# HISTORIC LANDMARK COMMISSION

## STAFF REPORT

**Trudell/Thompson Window Replacement  
PLNHLC2010-00057  
249 South 1100 East  
May 5, 2010**

**Exhibit C –  
Photos – Front Facade**

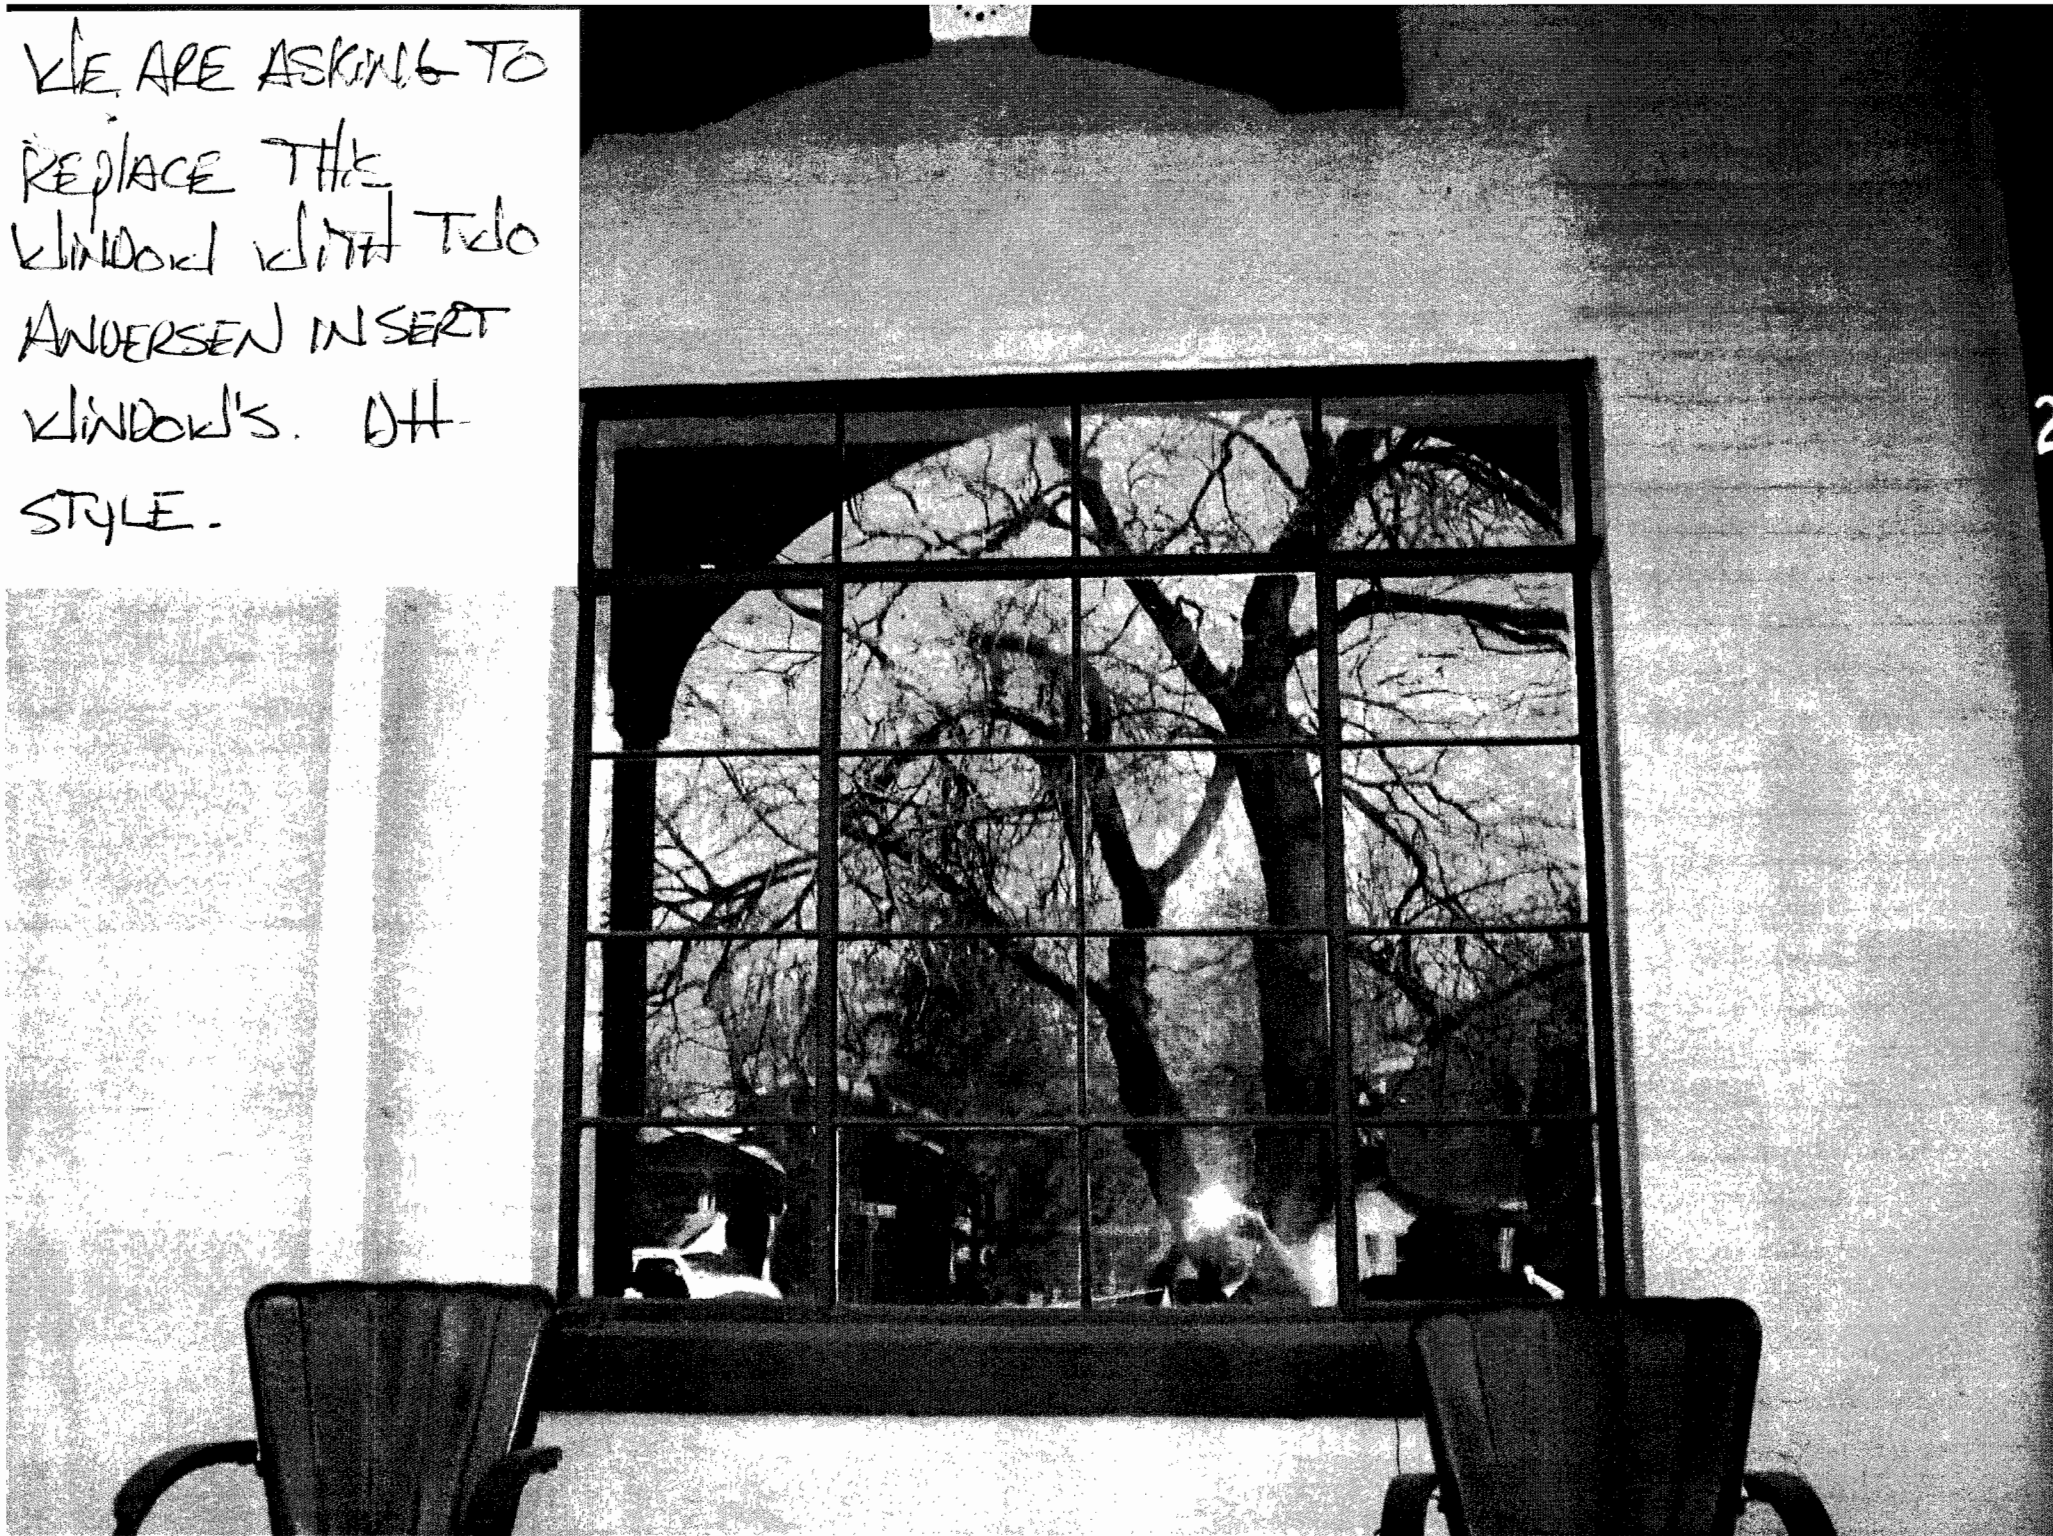
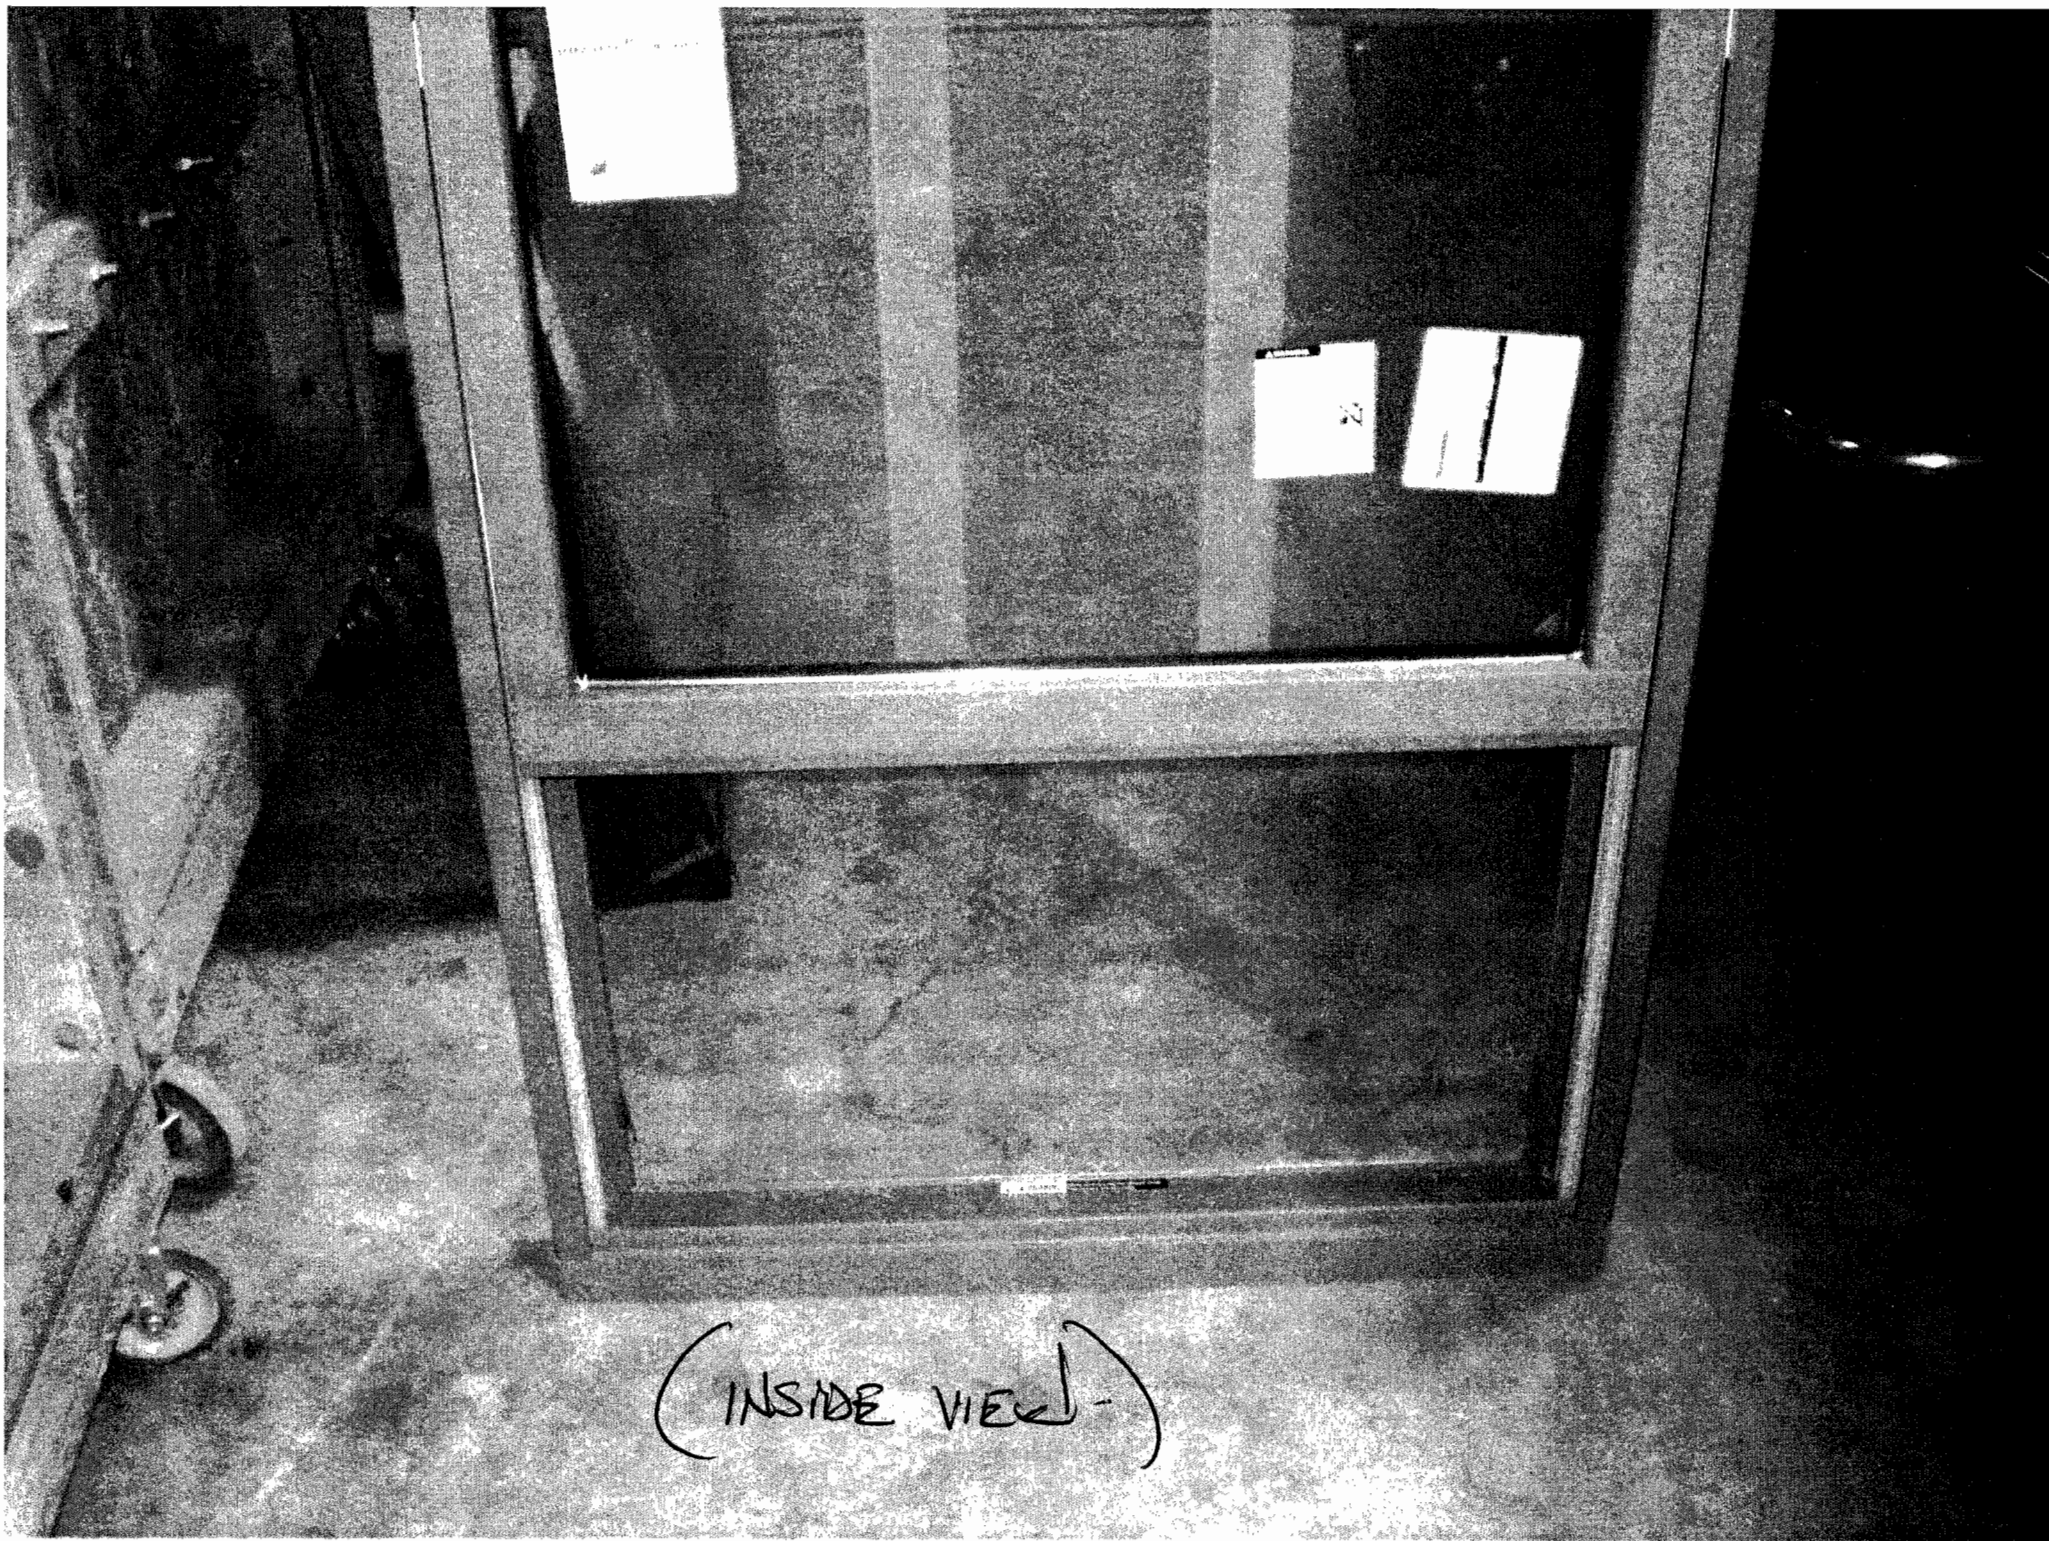
**Discussion for Standard 2:** As previously noted, the subject home has been significantly altered over the years, particularly the front façade. When considering the replacement of the existing windows on the front façade, Planning Staff asserts that the single or double-hung window configuration as shown in the attached historic photo from 1936, is an appropriate window style for the subject home. Planning Staff asserts that the proposed double-hung windows for the front façade honor the historic character of the structure. This type of window is typical of, and consistent with, the architectural style and age of the subject home. Photos of the existing and proposed front façade windows are attached for review (Exhibit C). Specification and technical information for Anderson Double-Hung Windows is also attached (Exhibit G).

Planning Staff's main concern with the proposed side-by-side double-hung windows is that there is no significant mullion feature separating the windows. Essentially, the proposed windows are separated by the width of the window frames. Typically, a more substantial mullion would separate side-by-side windows of this nature. Further, a window grid pattern is not evident on any of the historic photos that Planning Staff has been able to obtain. An internal grid (sandwiched between the double panes of glass) has been installed on the upper-level front façade windows. Planning Staff asserts that a grid pattern is not consistent with the historic characteristics of the windows that were in this home in 1936. Therefore, the grids should be removed from the newly replaced windows, and should not be included in any further replacement windows. To Planning Staff's knowledge, internal grid patterns are never appropriate for windows on the primary façade (and perhaps secondary or rear facades) for structures in the City's historic districts, nor have they ever been approved.

**Findings for Standard 2:** In general, the side-by-side double-hung windows installed, and those proposed, on the front façade retain and preserve the historic character of the subject home. The absence of a substantial mullion feature between these windows is inconsistent with the historic configuration of windows of this nature, and therefore somewhat detracts from retaining and preserving the historic character of this property. To be more historically characteristic, a substantial mullion feature is needed. Because of the lack of this feature in the windows installed and those proposed on the front façade, Planning Staff asserts that these windows do not meet this standard. Further, any simulated light grid pattern in the installed or proposed windows does not reflect, retain, or preserve the historic character of the home and should therefore be removed and/or eliminated as proposed. Finally, the picture window proposed on the north façade does not meet this standard, as it does not reflect, retain, or preserve the historic character of the property.

**Discussion of Standard 6 in relation to the front, north, and rear façade windows:** The double-hung windows chosen for the front façade generally meet the design criteria for replacement windows. The style is likely similar to the originals based on historic photos, and the profile of the windows generally meet the criteria as well. The window's wood composition material is one that has been allowed in the past and is therefore appropriate in this instance. To reiterate previous discussion, the issue with the proposed side-by-side double-hung windows on the front façade rests primarily with the lack of a substantial mullion feature, and the inclusion of a simulated divided-light grid pattern.

**Findings for Standard 6 in relation to the front, north, and rear façade windows:** In general, the windows installed, and those chosen for installation, on the front and rear facades of the home, meet Standard 6 based on duplications of features that are substantiated by historic pictorial evidence. The configuration of the front façade windows are somewhat problematic because of the lack of a mullion
